DEE WHY RSL CLUB LTD

STAGE 5 - CLUB EXTENSION

ACCESS REVIEW S96

19th February 2018

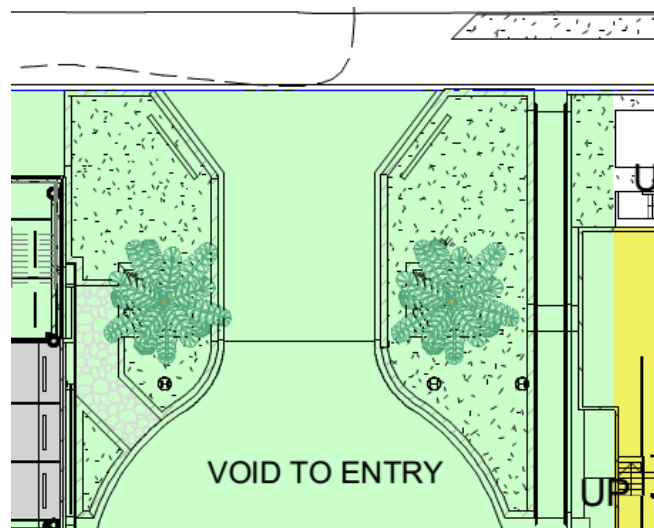
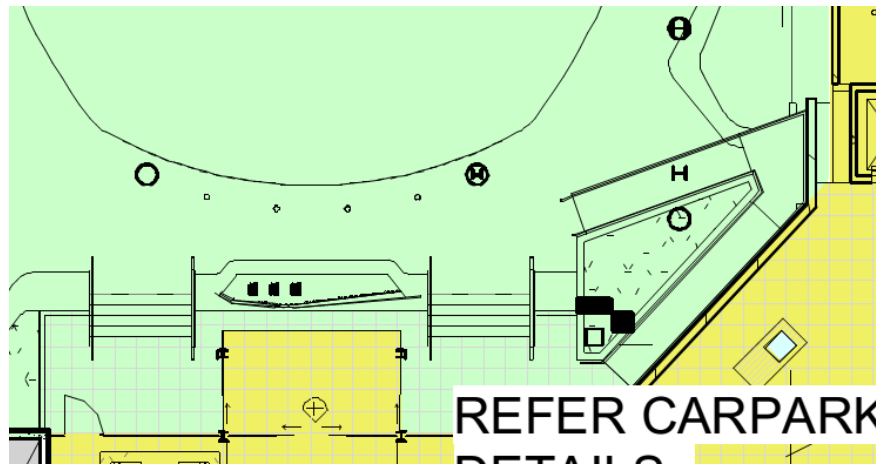
Currently the Stage 5 extension drawings show a straight ramp. This is an efficient, universal accessible path of travel from the site boundary to the vehicle set down area. A handrail has been proposed on both sides of the ramp compliant with AS1428.1.

- (i) Handrail to be compliant with AS1428.1
- (ii) Tactile Ground Surface Indicators to be provided near both ends of the ramp compliant with AS1428.1.
